AMENDMENT REPORT

Dunedoo Solar Farm

March 2021

Project Number: 20-764

Figure 3-1 Heavy vehicle construction entry (red) and exit (blue) routes (Memo Figure 4)

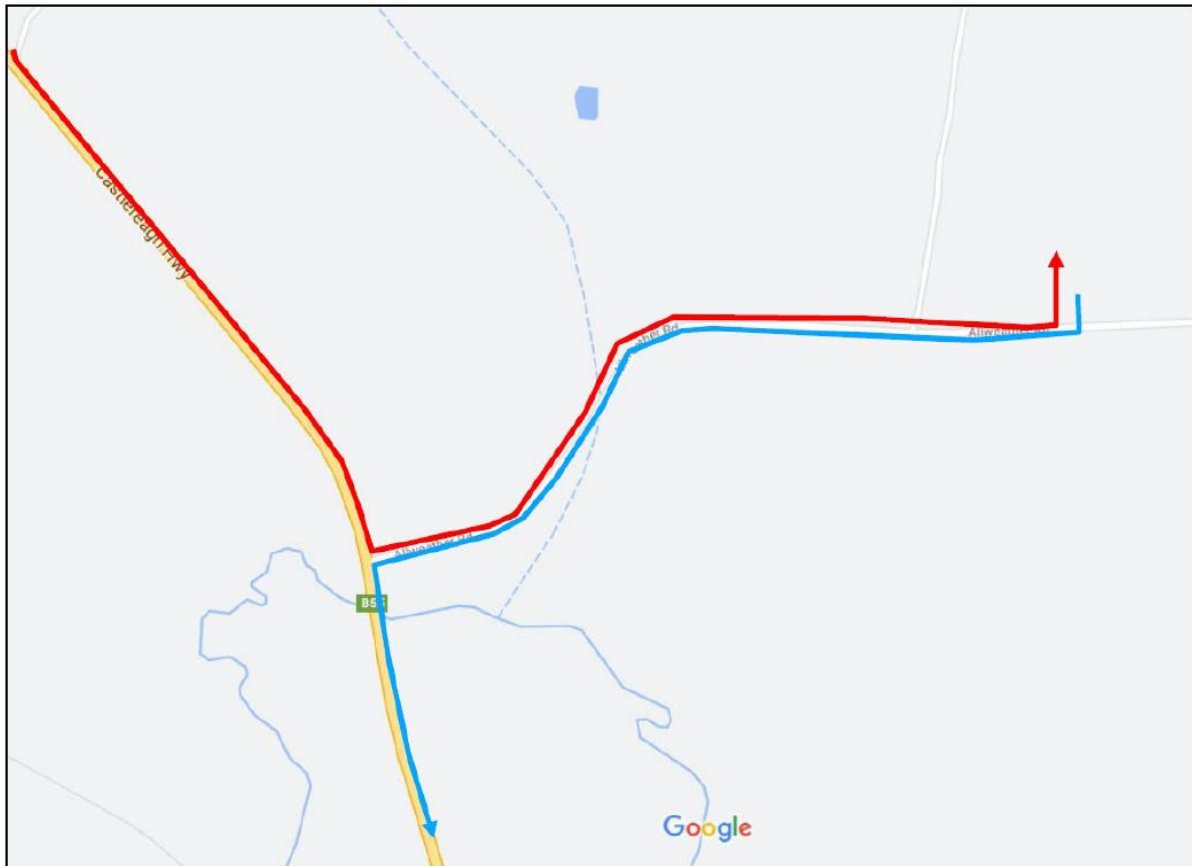
- Heavy vehicles would generally enter south along Castlereagh Highway and turn left via the intersection into All Weather Road and left into the site entry as shown in Figure 3-1 below. Right turns from Castlereagh Highway via the intersection into All Weather Road will be prohibited and vehicles approaching All Weather Road from the south travelling along the Castlereagh Highway will be required to travel north to Mendooran and turn around to allow entry to site from the north. Two options are proposed for the turnaround (see turn around detail in Figure 3-2 and Figure 3-3 below); and

- Vehicles would exit the site and turn right to travel west along All Weather Road and then turn left into Castlereagh Highway via the intersection as shown in Figure 3-1 below. Right turn from All Weather Road into Castlereagh Highway via the intersection will be prohibited and vehicles needing to travel north on the Castlereagh Highway will be required to travel south to Dunedoo and turn around (see turn around detail below in Figure 3-4 below) before re-entering the north bound Castlereagh Highway.

Figure 3-2 Mendooran turn around Option 1 detailed (following Castlereagh Highway, Pampoo St, Cobra St, Brambil St and Castlereagh Highway) (Memo Figure 5)

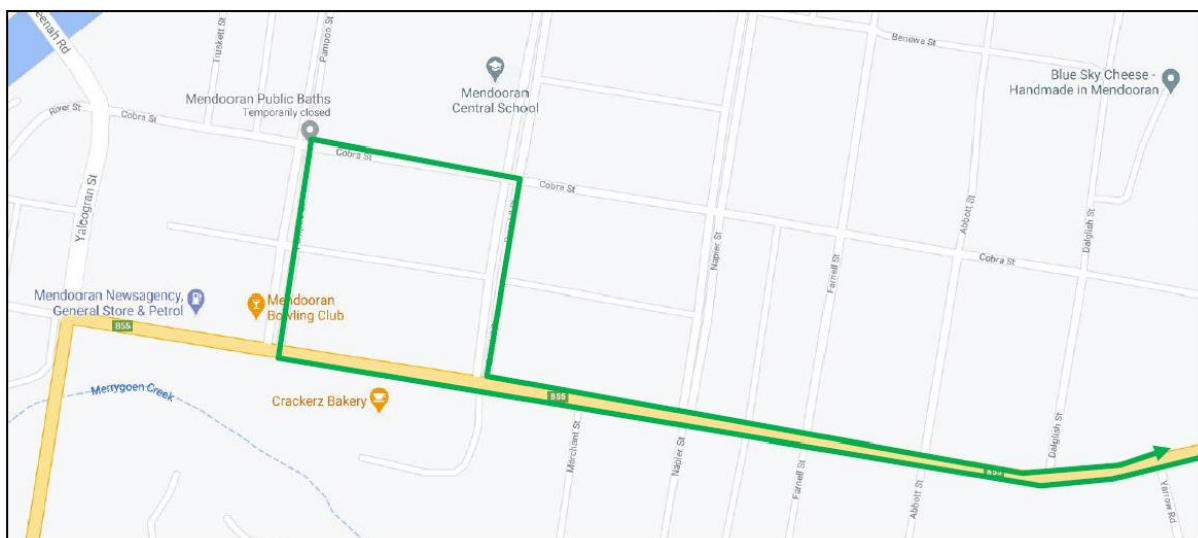
In Mendooran, Pampoo Street was selected as the preferred right turn location due to its wide entry, the passing lane to the left and avoidance of other obstacles such as low overhead wires (see Figure 5 above). Similarly, the other three intersections discussed in Section 3.2.2 above, have wide and appropriate geometry. However, it is noted that this route will direct construction vehicles through residential streets of Mendooran, and as such, a second route is proposed which will require construction vehicles to use Denmire Road and turn right onto Castlereagh Highway from Yarrow Road (see Figure 3-3).

Figure 3-5 AUL(S) concept design by LG Civil on Castlereagh Highway and All Weather Road

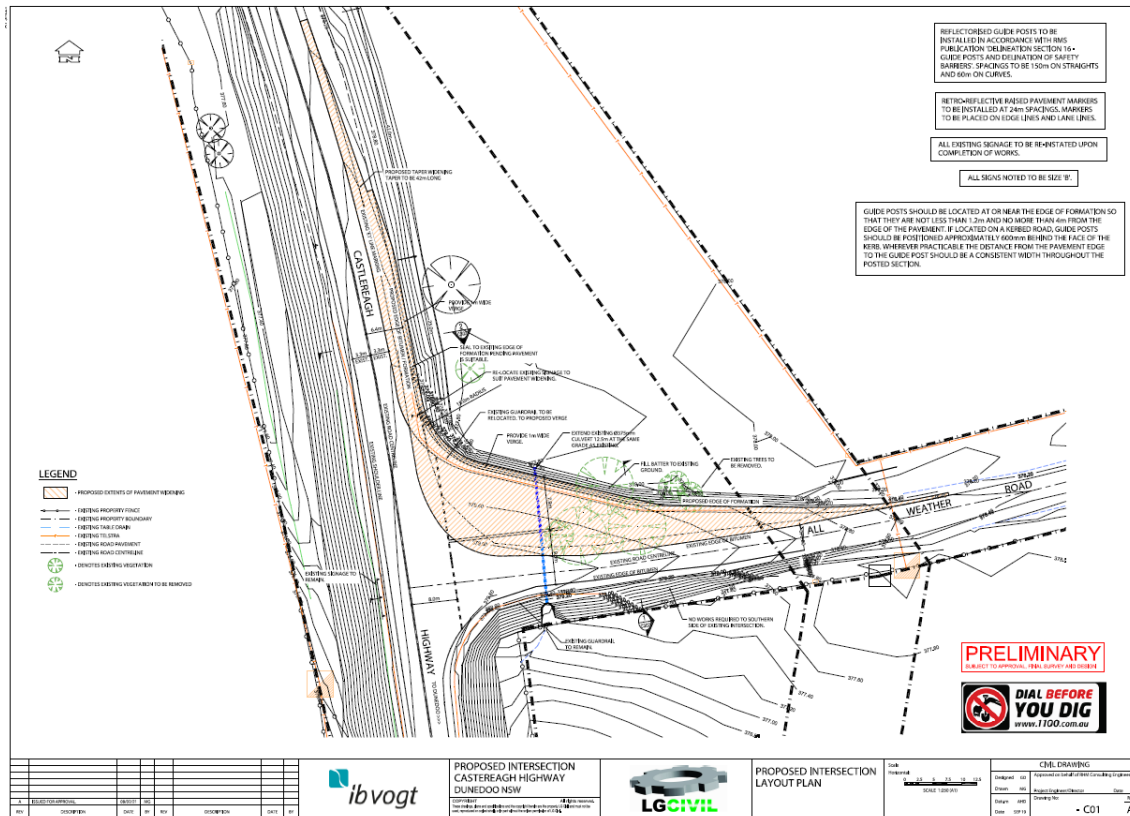
- AUL(S) design as shown in Figure 3-5. This is in advance of the BAL treatment requirement under the Austroads design requirements;
- Caters for the largest design vehicle, which is a 26m B-Double (refer Figure 3-6);

The concept design is an appropriate treatment for the intersection and significantly increases its safety during construction and in the long term.

Figure 3-6 Swept path analysis for AUL(S) concept design by LG Civil on Castlereagh Highway and All Weather Road

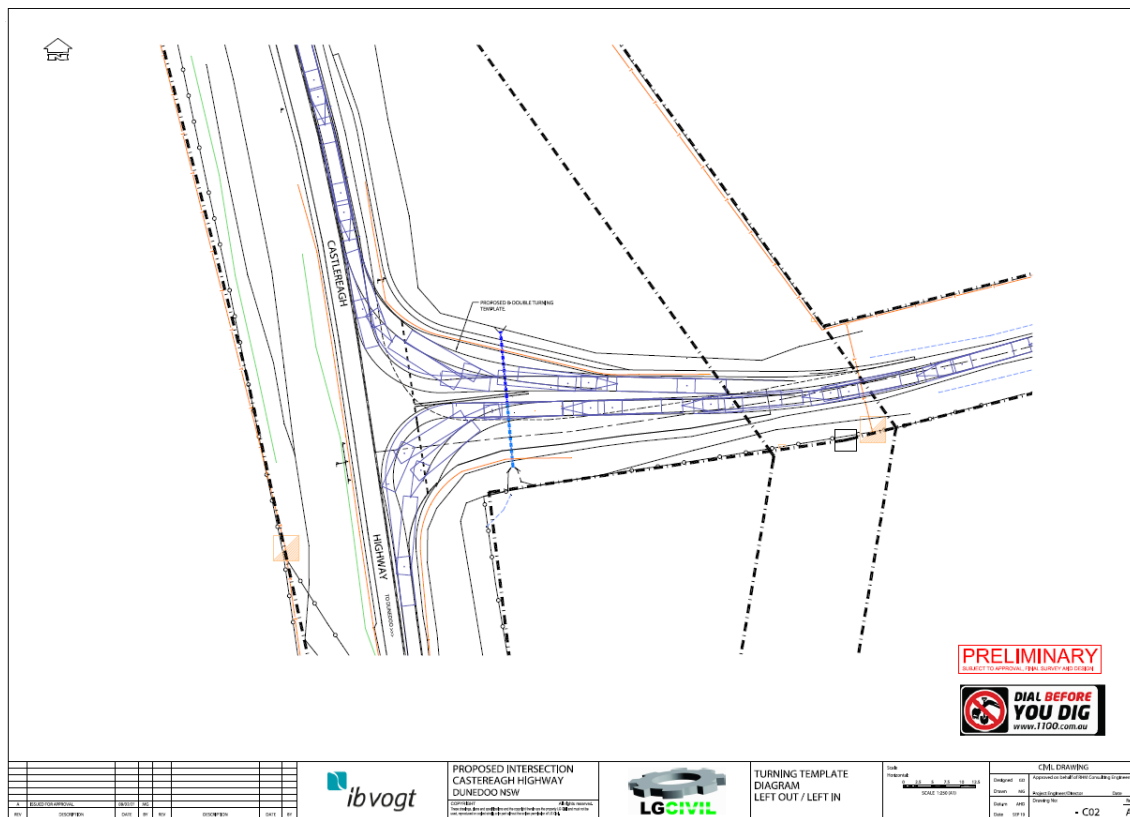
- Swept paths (refer Figure 3-6), prepared by LG Civil, shows simultaneous in and out bound left turns of the largest design vehicle are maintained with the correct direction of travel, minimising the chance of stationary vehicles on the Castlereagh Highway as far as reasonably possible;

The largest heavy vehicle that will be used during the construction of the proposal, has been reduced to a 26 m B-Double. This responds to RAVMAP requirements. Swept paths at the intersection have been updated (Refer to Figure 3-6) to reflect the new requirements and demonstrate the smaller design vehicle can safely negotiate the concept AUL(S). (Refer to Section D and Attachment C of Appendix C).
